City of Duluth

City of Duluth Bid # 13-0426
Job Description: Cross City Trail
City Project No. 0568TR
S.P. 118-090-020 and 118-090-022

Addendum #1

TYPICAL SECTIONS

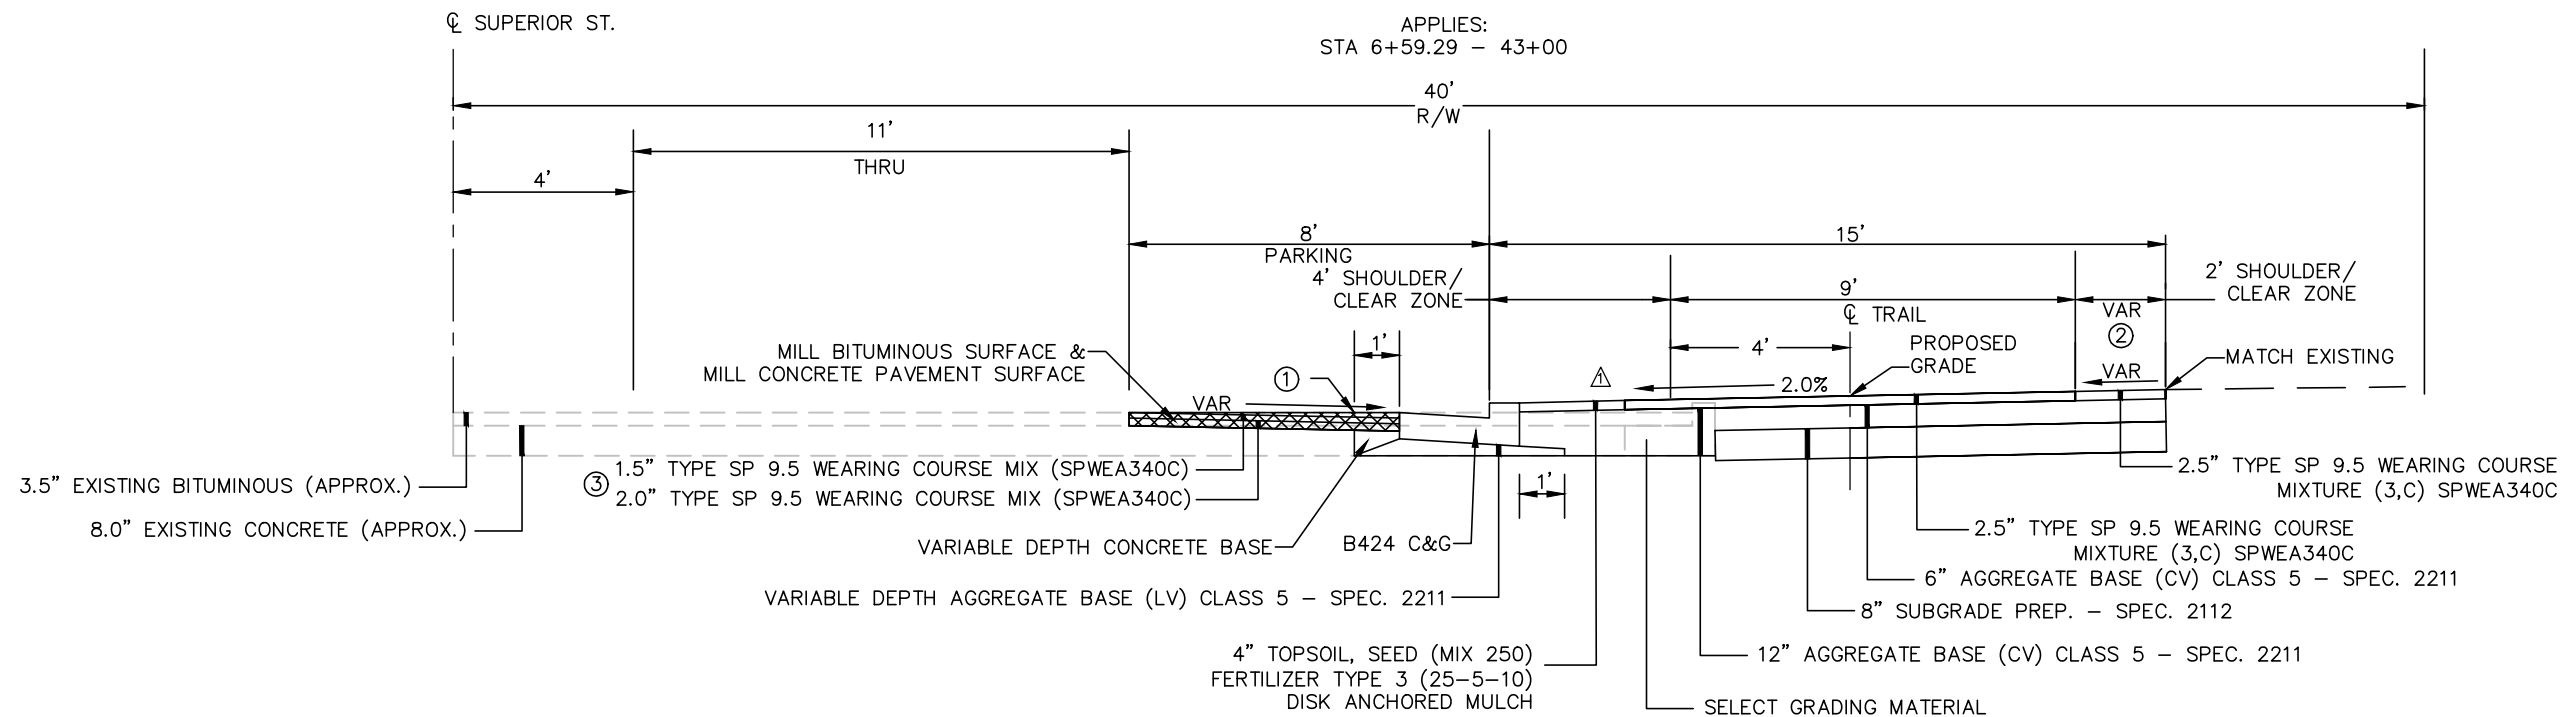
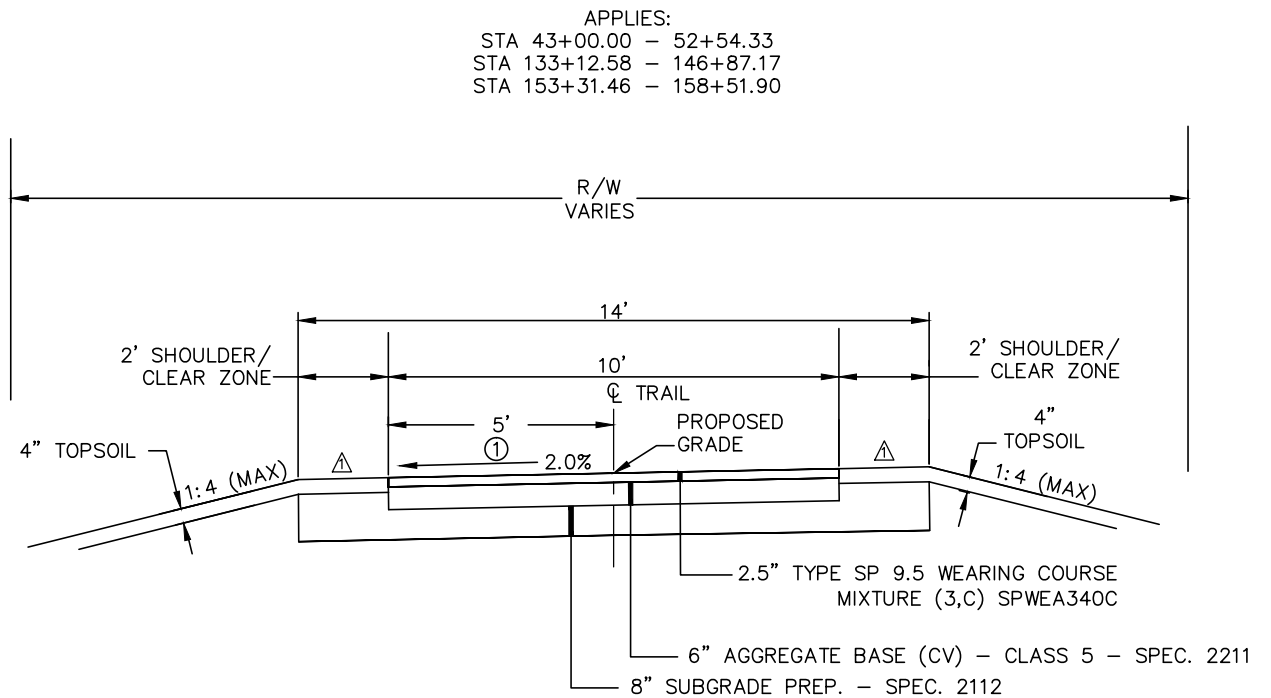
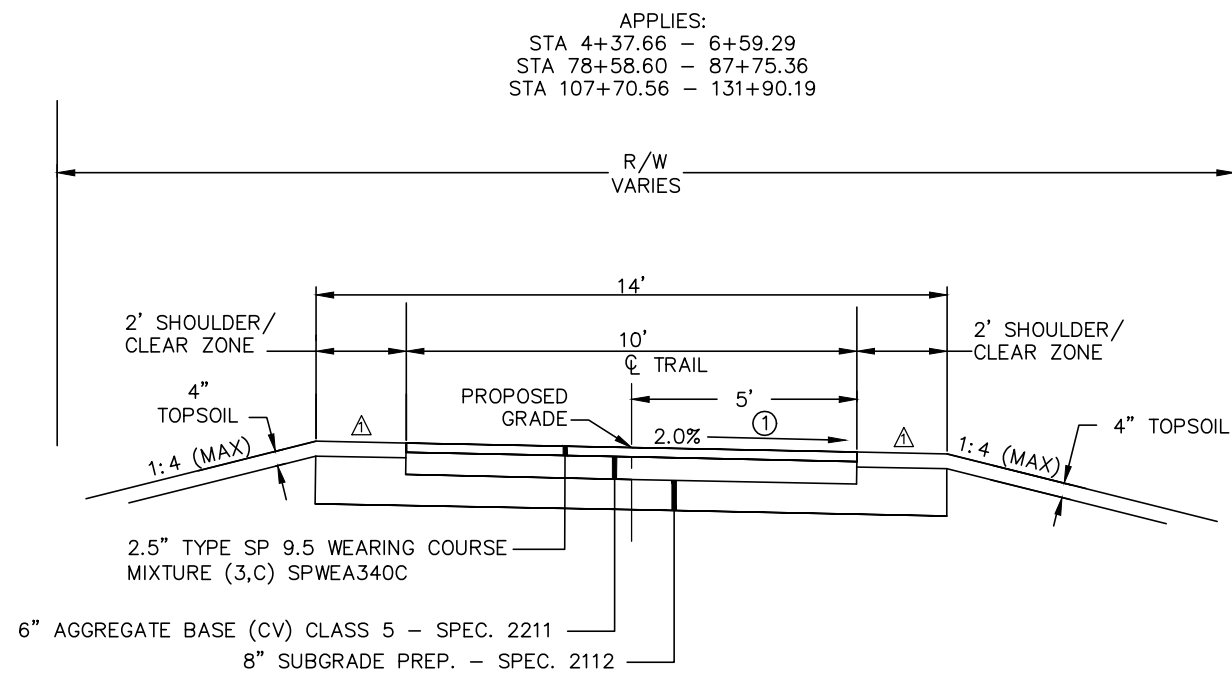
CHANGED SHOULDER TO SEEDED TOPSOIL FROM BITUMINOUS
CHANGED SHOULDER WIDTH FROM 3' TO 4'
CHANGED TRAIL WIDTH FROM 10' TO 9'

TYPICAL SECTIONS

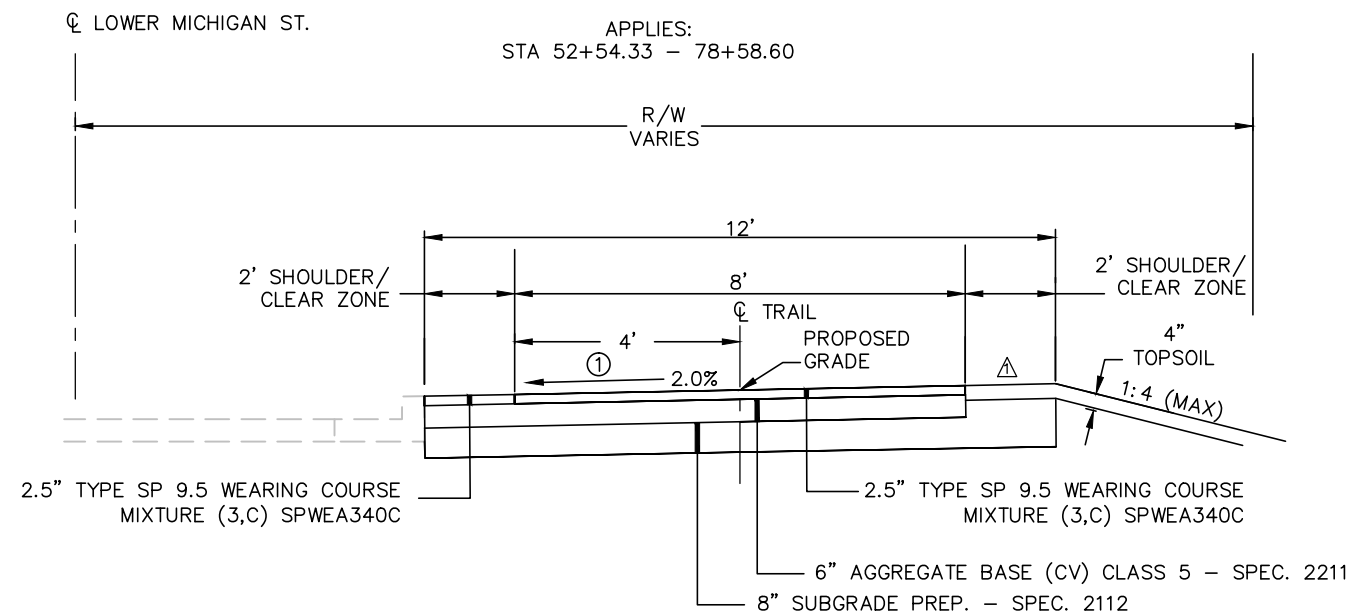
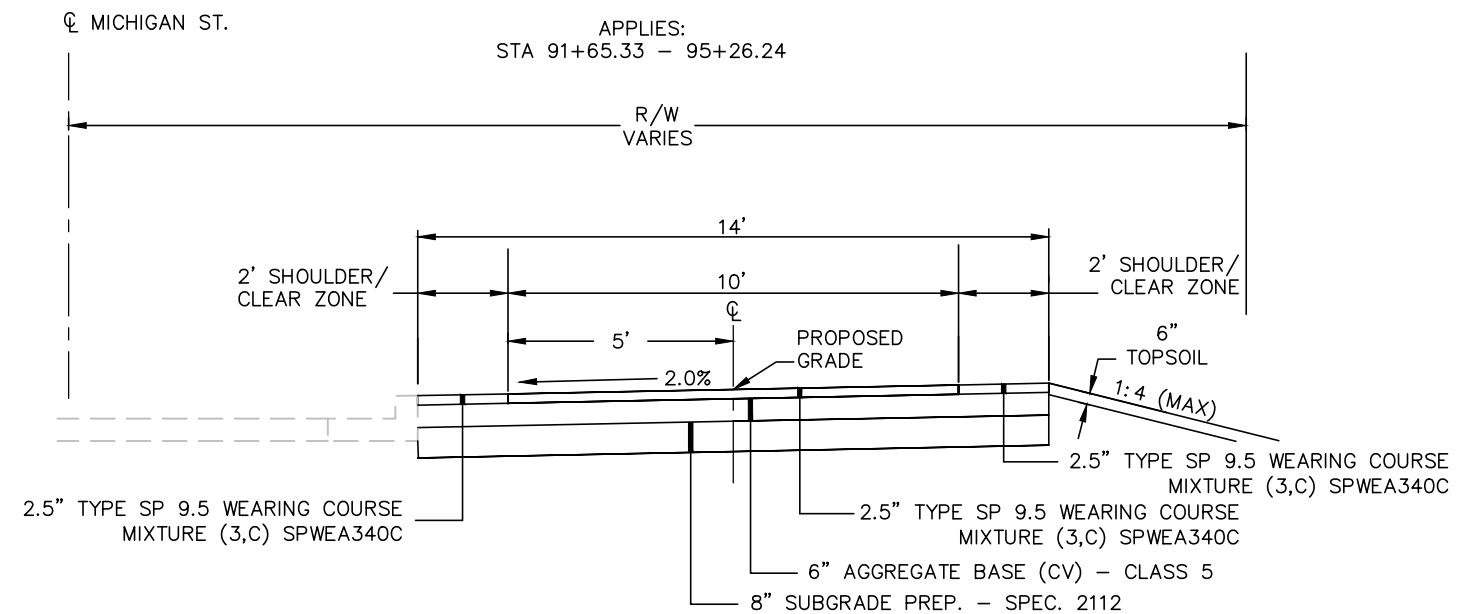
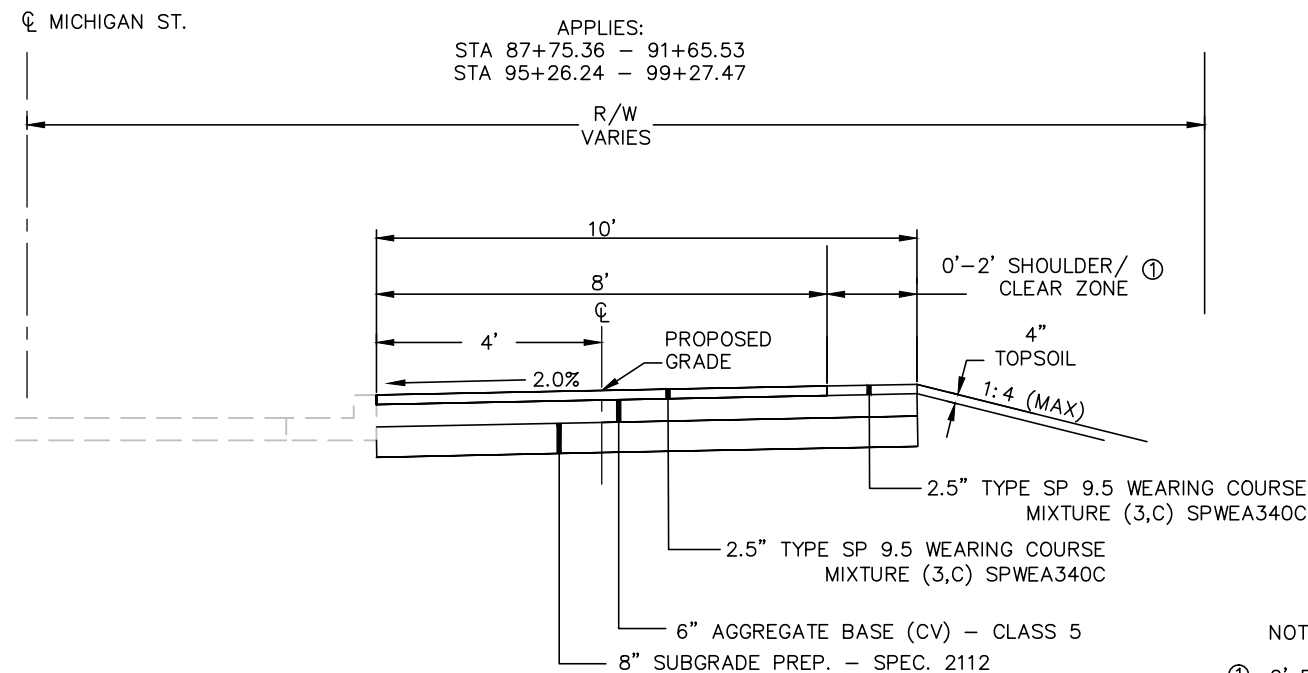
CHANGED SHOULDER TO SEEDED TOPSOIL FROM CLASS 5

TYPICAL SECTIONS

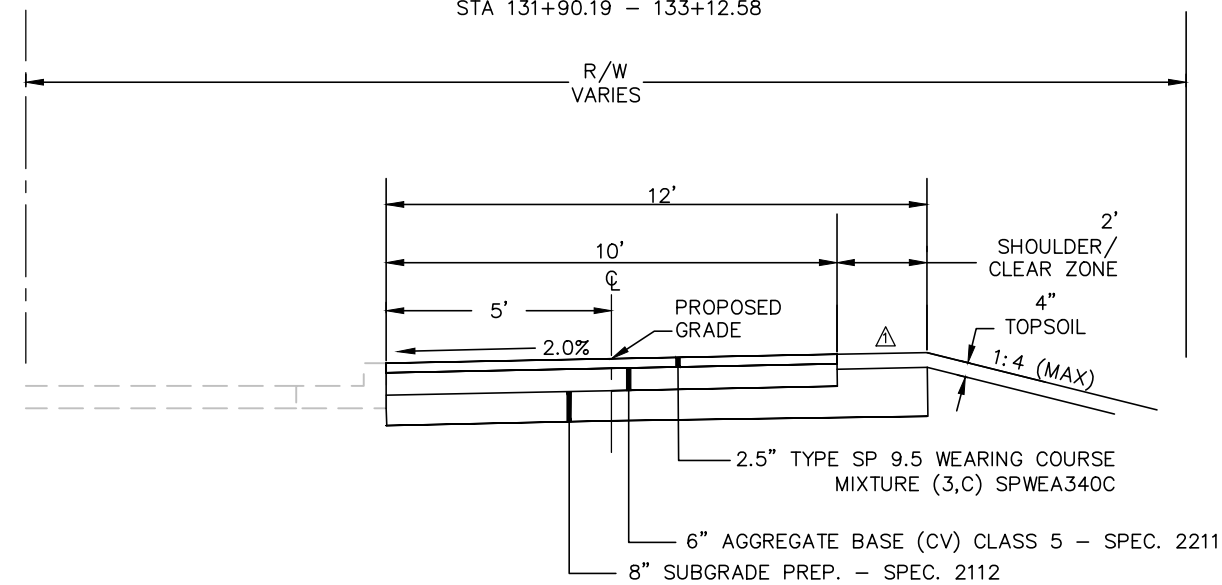
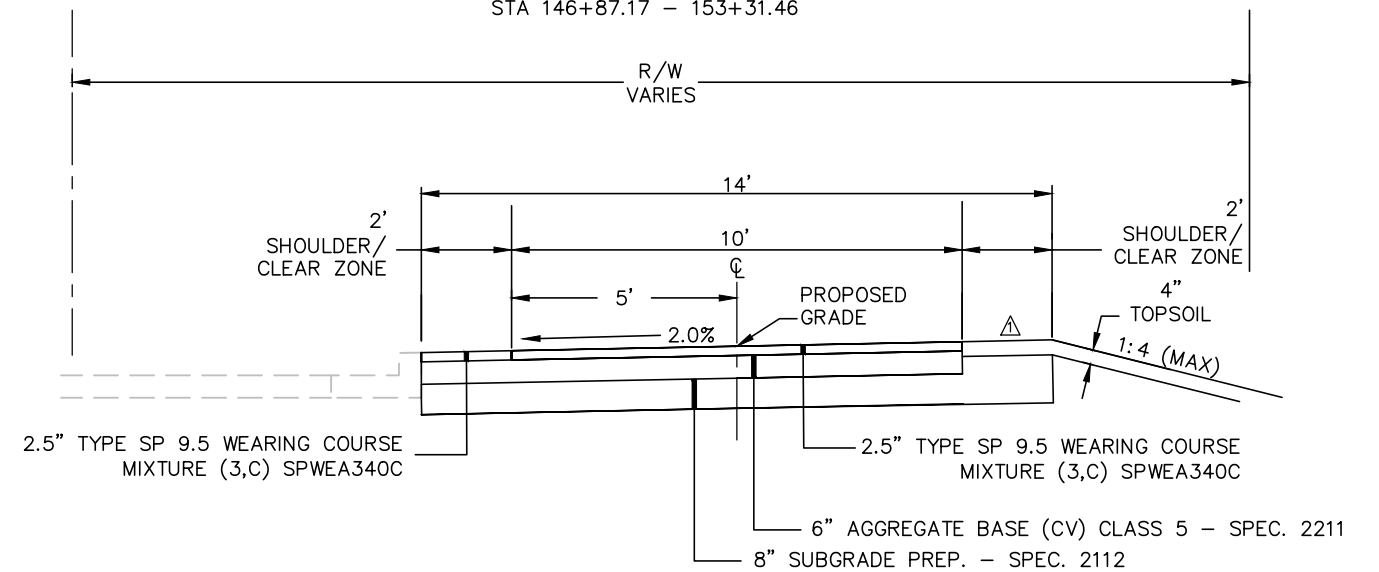
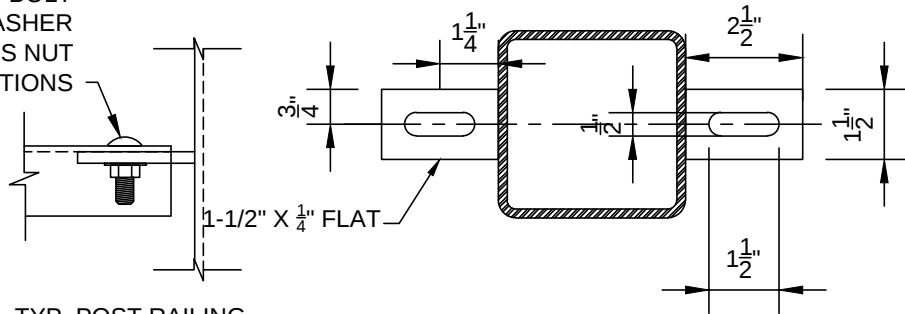
DRAWN BY: ACO	ACO	7/16/13	CHANGED SHOULDER TO SEEDED TOPSOIL FROM CLASS 5
DESIGNER: JCK			
CHECKED BY: MJB			
DESIGN TEAM	NO.	BY	DATE
			REVISIONS
